Re: VAI Response to Traffic Engineering Peer Review
Town Yard Redevelopment
Andover, Massachusetts

Vanasse & Associates, Inc. (VAI) is responding to comments that were raised in the January 25, 2024 *Traffic Engineering Peer Review* letter prepared by The Engineering Corp (TEC) concerning their review of the November 9, 2023 *Transportation Impact Analysis* report that was been prepared by VAI in support of the proposed town yard redevelopment to be located in Andover, Massachusetts (hereafter referred to as the “Project”). Listed below are the comments that were identified by TEC in the subject letter that pertain to the November 9, 2023 report and require a response, followed by our response on behalf of the Project proponent.

Delivery Truck Turning Analysis
Entering from Pearson Street
and Exiting to Lewis Street

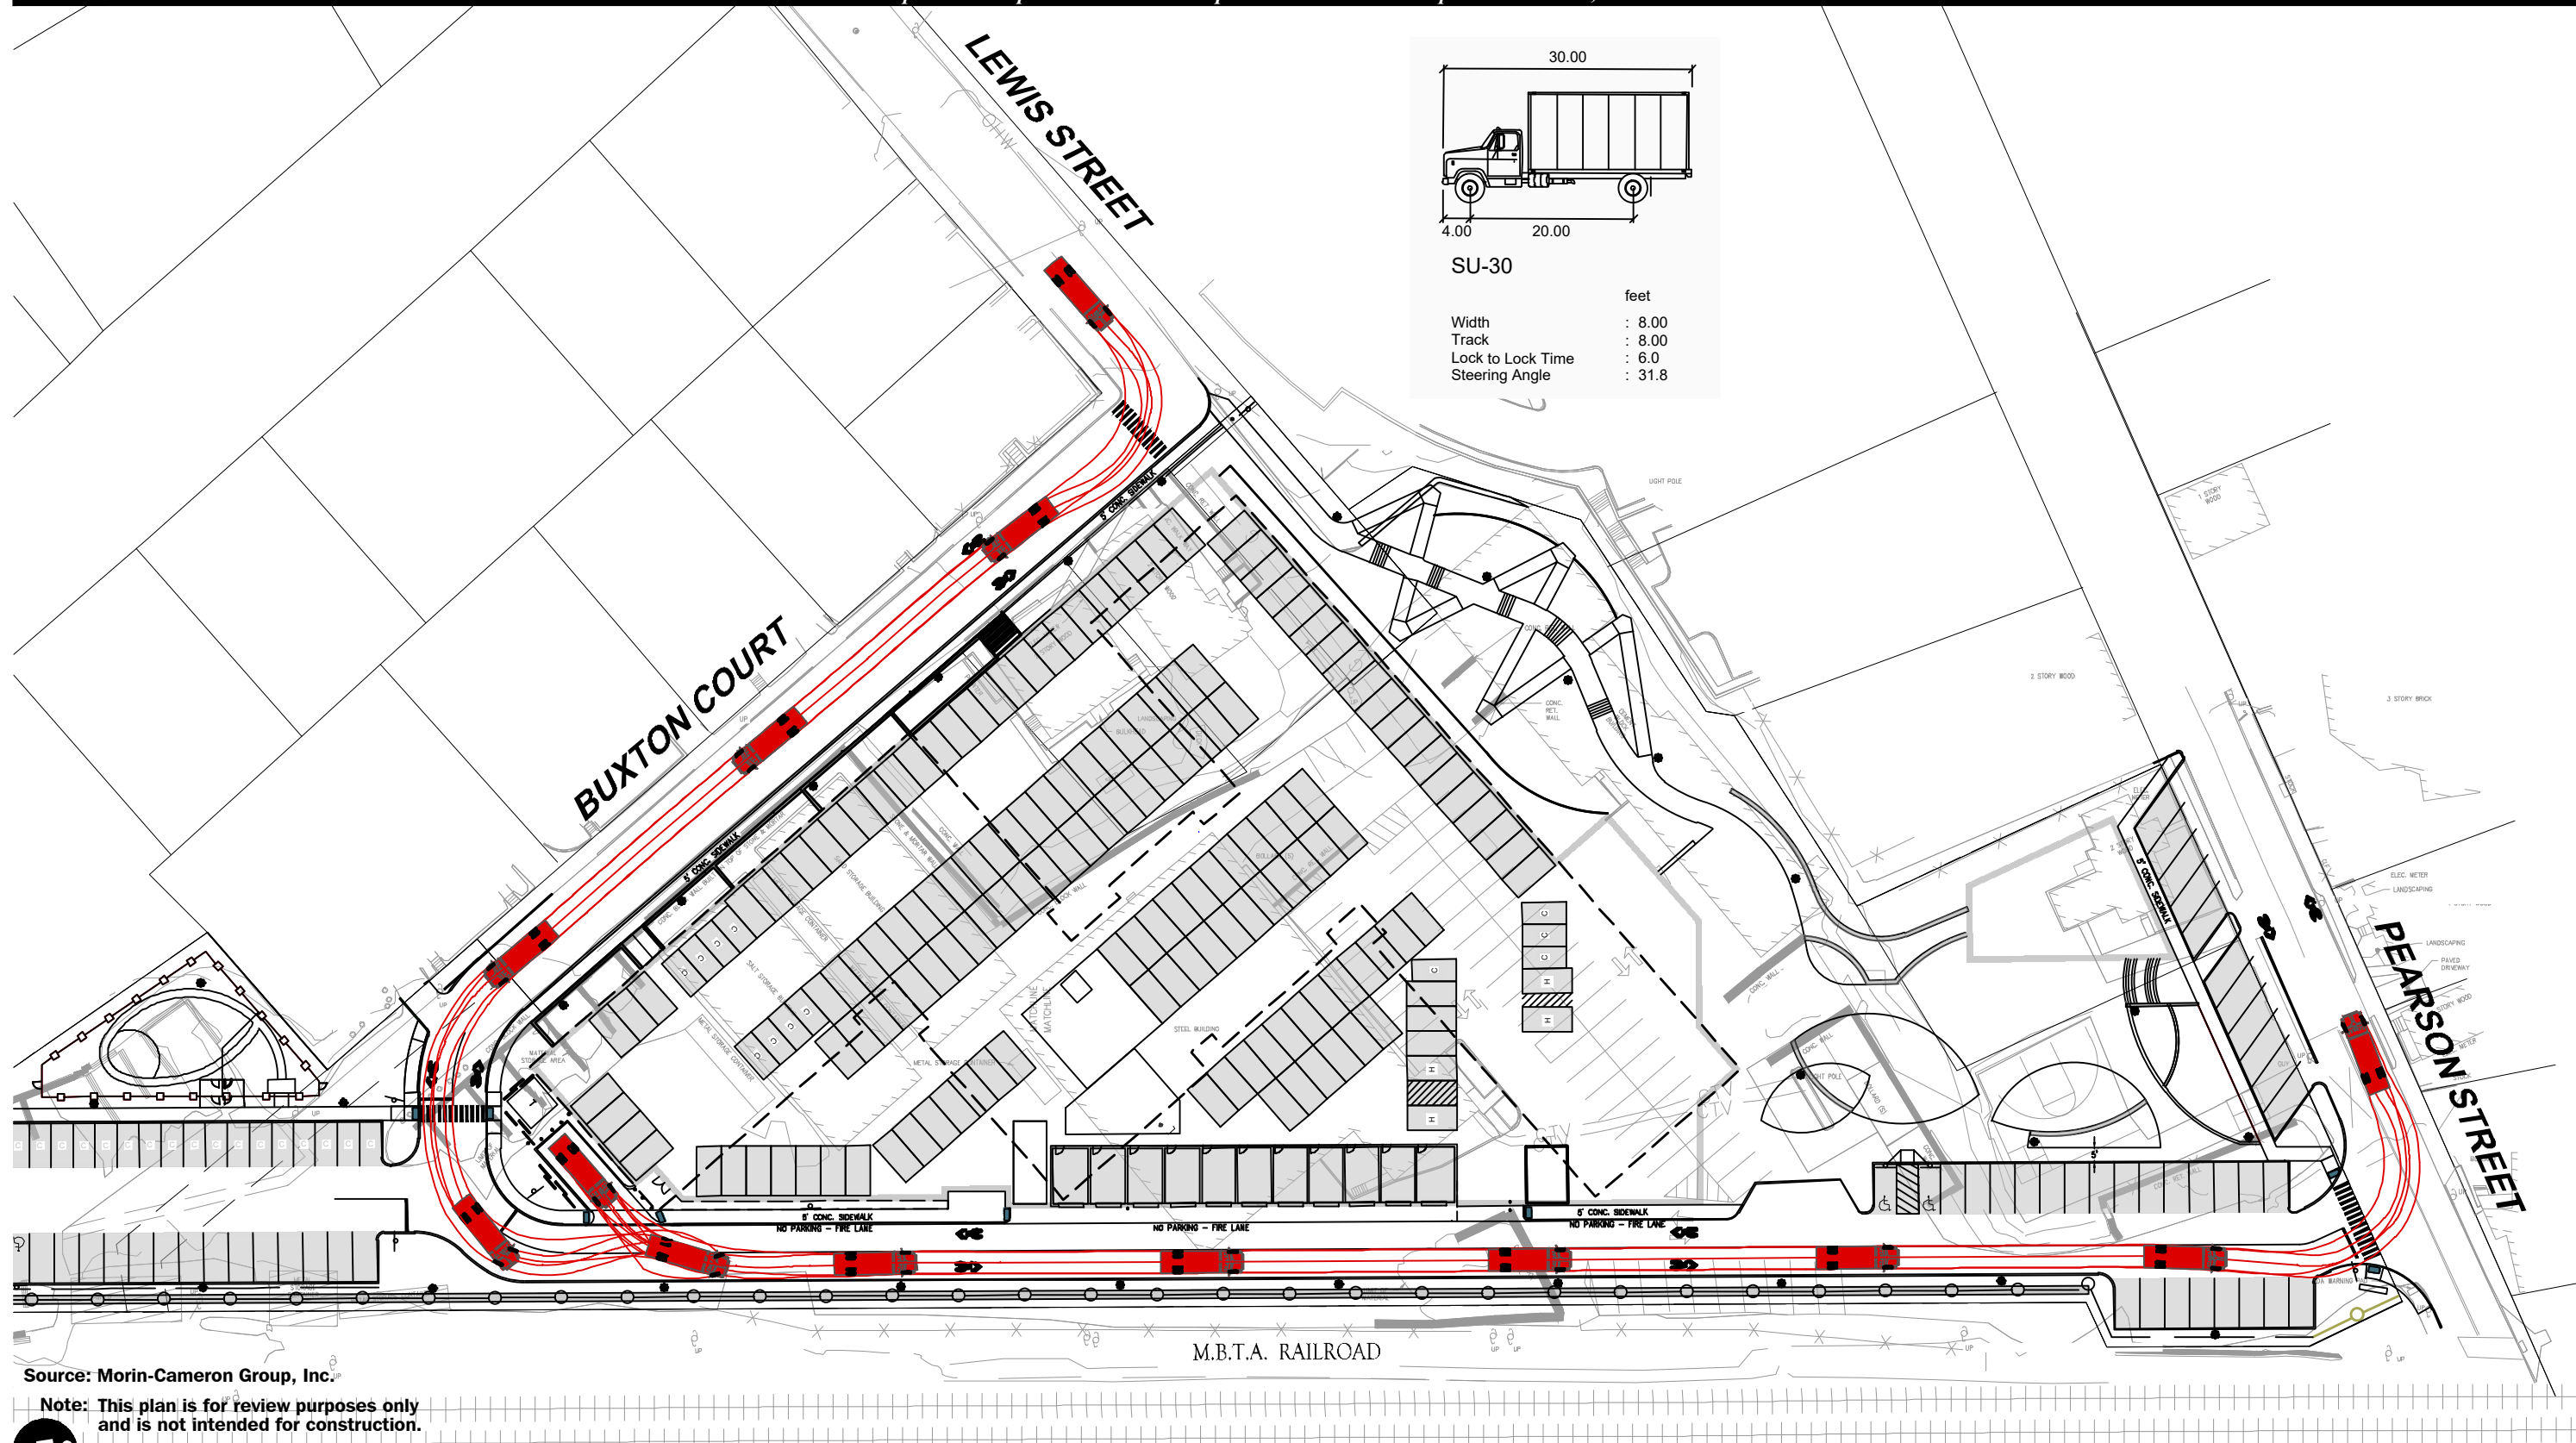
Comment 35: *The Applicant should provide turning templates showing the ability of the standard delivery vehicle or service vehicle to be utilized on-site to access, circulate, and egress the site through the circulation pattern without leaving the paved surface and while providing access to the secured receiving area. The Applicant should confirm that this is or is separate from the 'drop-off' area at the southwest end of the building.*

MC Response: VAI has provided turning templates for the moving and delivery vehicles requested in the appendix to this letter. These paths depict vehicles utilizing the drop-off area near the building lobby as well as the loading area at the north end of the building.

Figure AT-4
Garbage Truck Turning Analysis
Entering from Pearson Street
and Exiting to Lewis Street

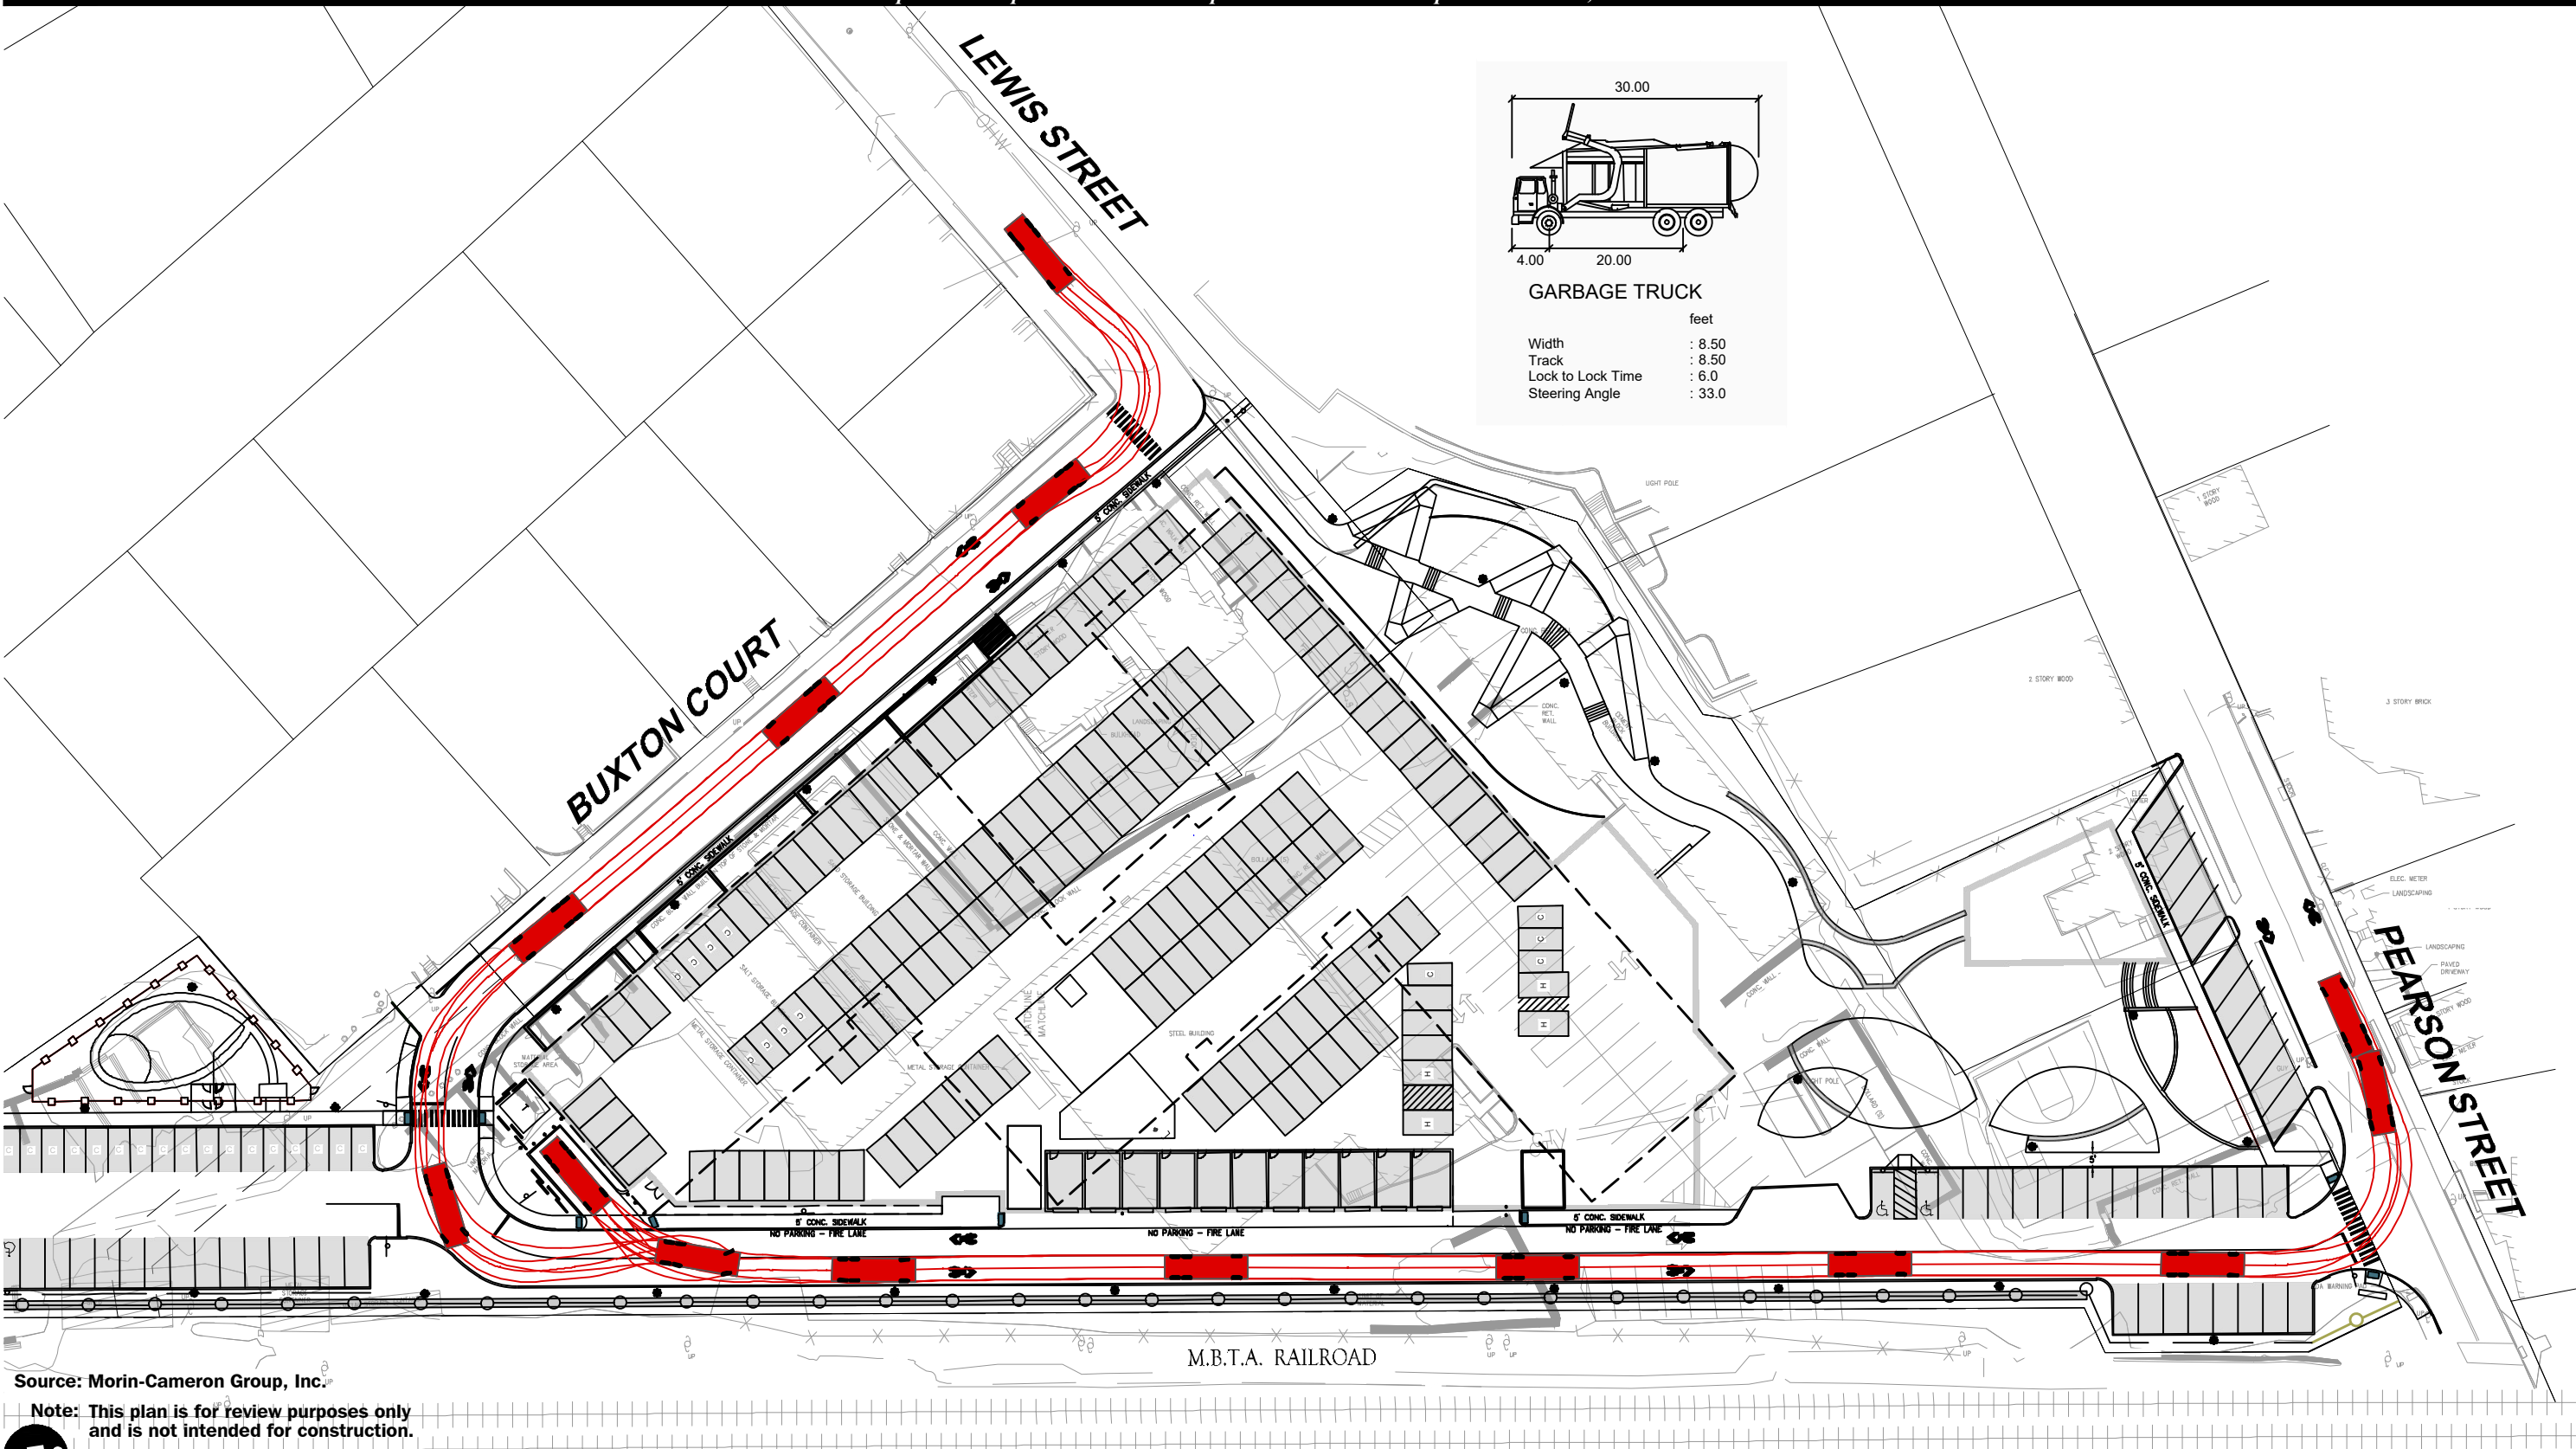
Comment 34: *The Applicant should provide turning templates showing the ability of refuse trucks to access, circulate, and egress the site through the circulation pattern without leaving the paved surface while providing access to the dumpster enclosures on the site.*

MC Response: VAI has provided turning templates for the refuse vehicle requested in the appendix to this letter. There are no dumpster enclosures; instead, dumpsters will be wheeled out of the garage for pickup from the lower circulating roadway.
